The Public Transport Association of Canberra (PTCBR) welcomes the Suburban Land Agency's community consultation regarding the Whitlam Local Centre.

We appreciate that consultation is in the early stages, and we would welcome the opportunity to further participate in consultations once the design for the local centre is more advanced. At this stage, PTCBR makes the following observations.

[Figure 1: Bus stop near Crace local centre, with poor passive surveillance]

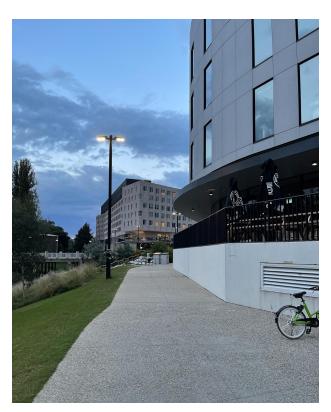
- Passive surveillance and good lighting. Stops should be within eyesight of active shopfronts, to
 increase perceptions of safety. In contrast, while the Crace shops are generally an example of a
 successful local centre, the bus stops at the Crace shops have poor passive surveillance, as they
 are located along the back wall of the local shops, on a quiet street, away from most shoppers
 (Figure 1).
